APPLICATION FOR PERMISSION
UNDER SECTION 16 OF
THE TOWN PLANNING ORDINANCE
(CAP.131)

Proposed Ancillary Guard House and Refuse Collection Point, Ancillary Storage Facilities and Staff Office, Additional Toilets and Modification to the Kitchen for Existing Yacht Club “Marina” Use.

**Proposed Ancillary Guard House and Refuse Collection Point, Ancillary Storage Facilities and Staff Office, Additional Toilets and Modification to the Kitchen for Existing Yacht Club “Marina” Use
Application No. A/SK-HH/80**

I refer to the email from the District Planning Officer / Sai Kung and Islands dated the 6 October 2022 which contained comments from the District Lands Officer / Sai Kung (DLO). Our responses to the comments are contained below using the same numbering as that used by the DLO.

Figure 1 Extract from the Hebe Haven OZP indicating the location of the Application Site

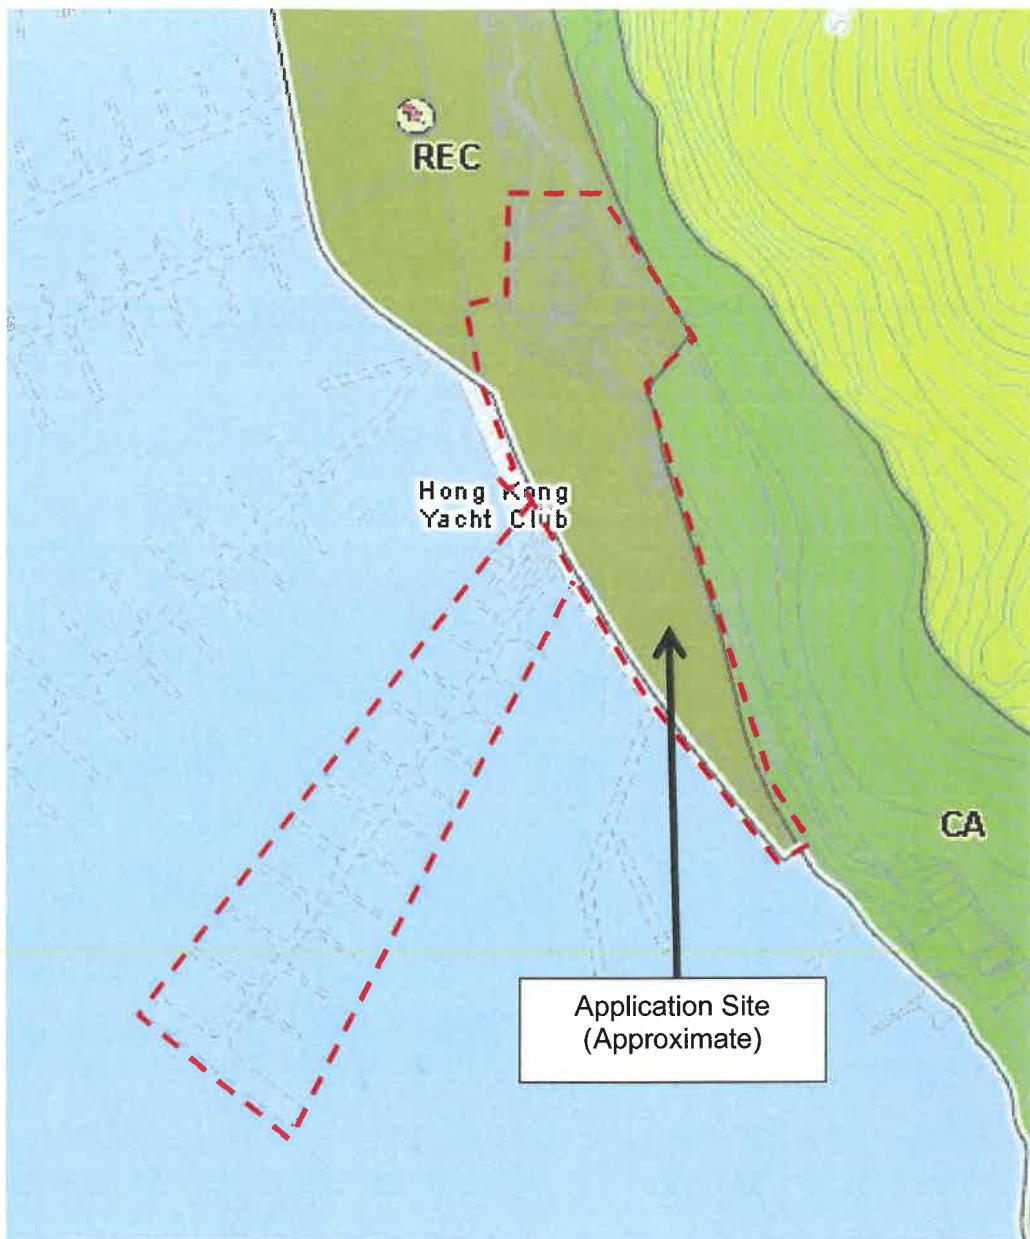
Furthermore, Attachment 2 is to replace Figure 1 of the submitted Planning Statement, where the Application Site boundary has been corrected.

Figure 2

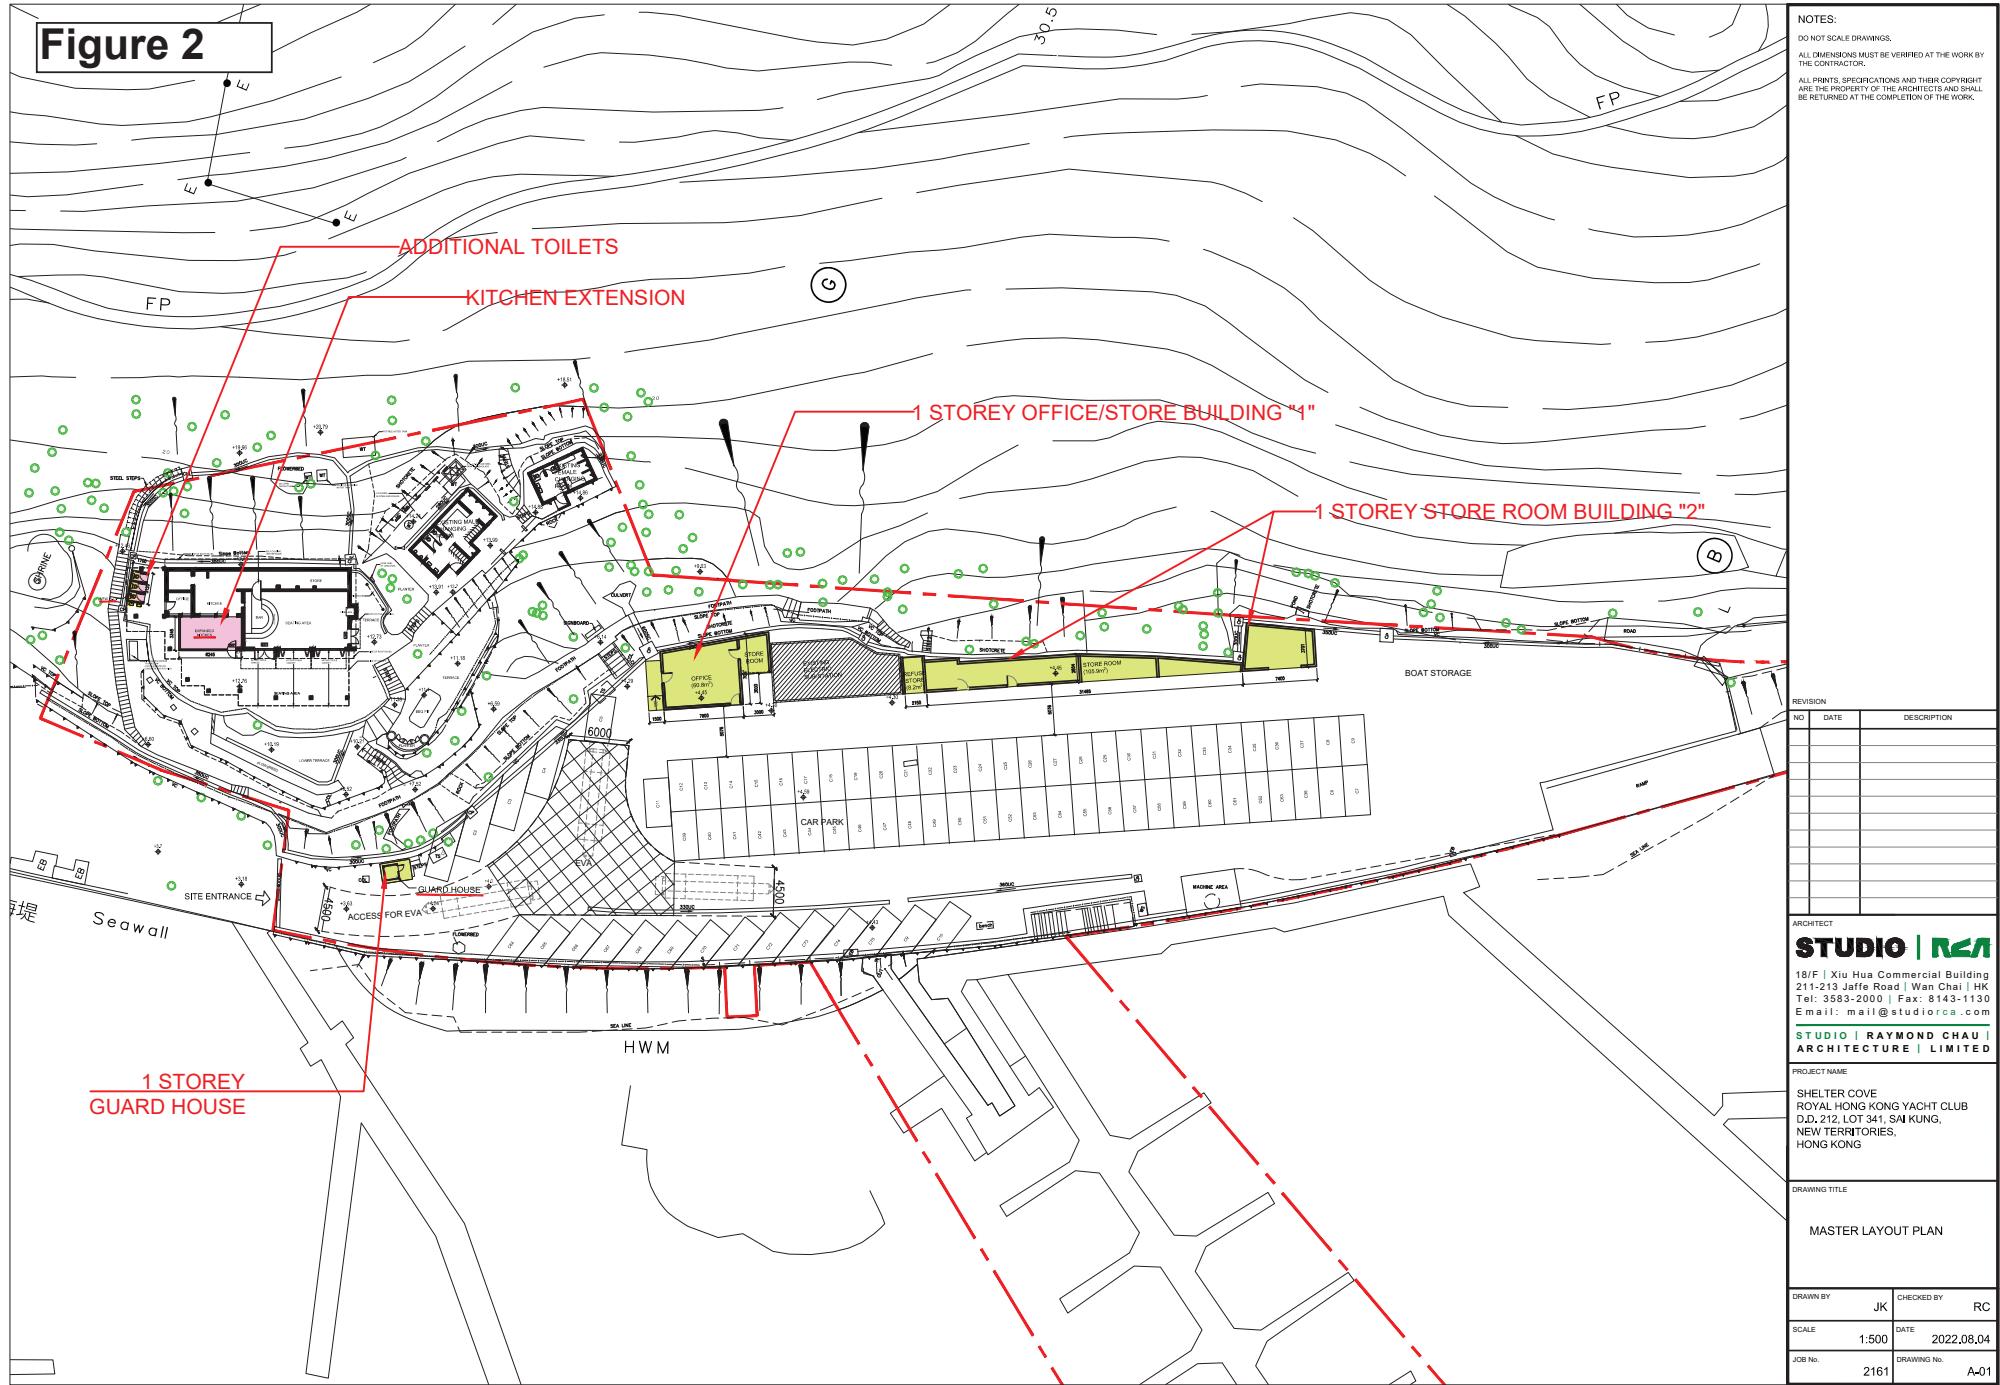
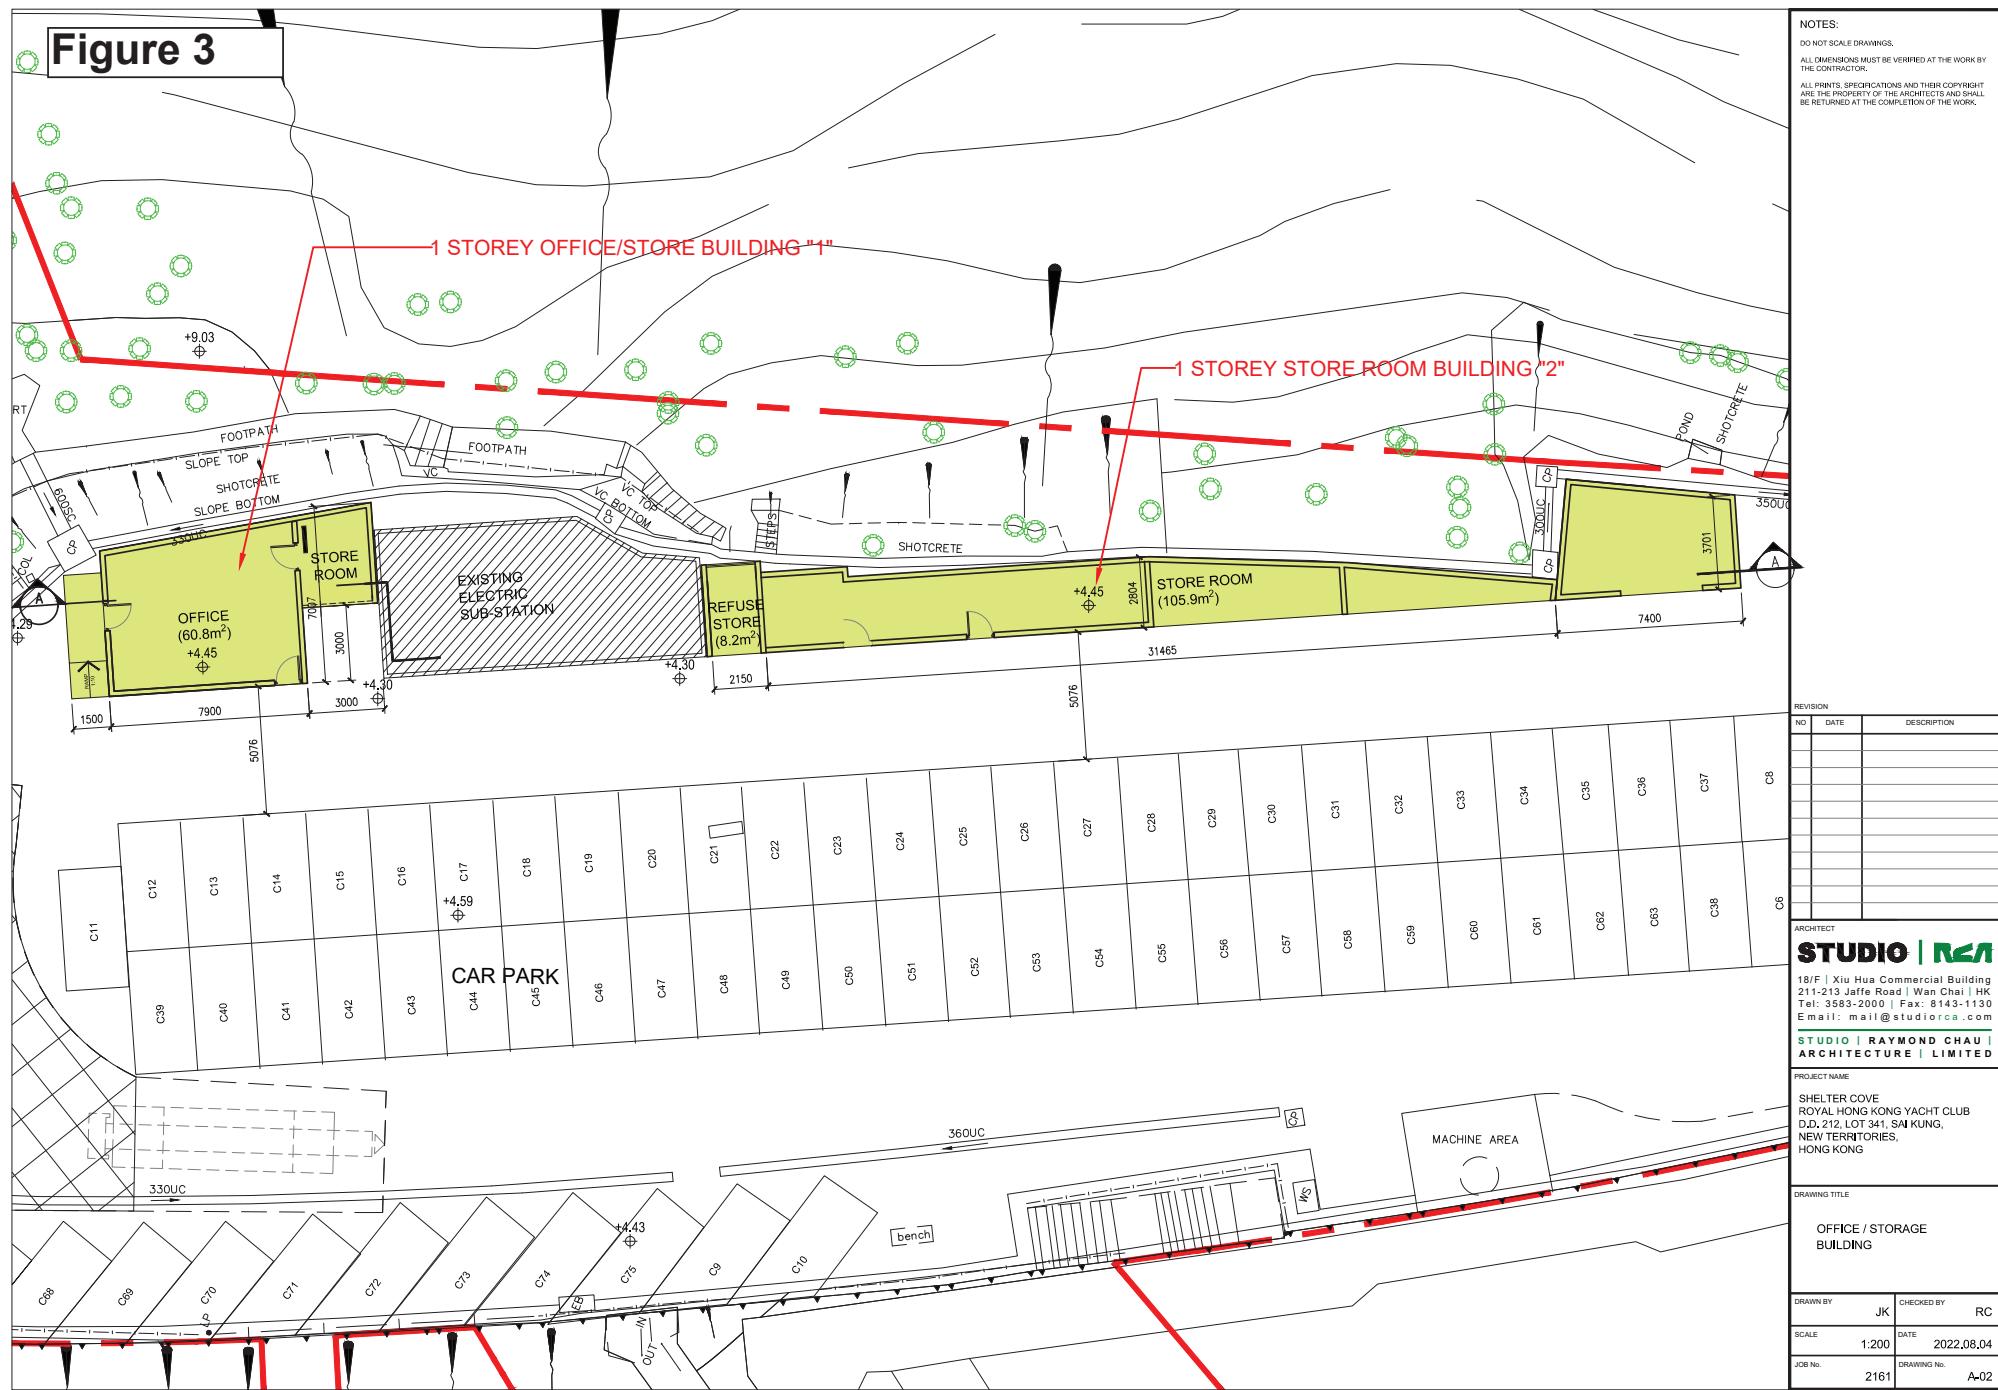
We would now like to make a clarification on the Planning Statement, which was submitted with the letter dated 5 August 2022. On Figures 2 and 3 of the Planning Statement, there was a typo of "8.68m²" referring to the proposed storeroom. These have now been omitted and the new plans are attached.
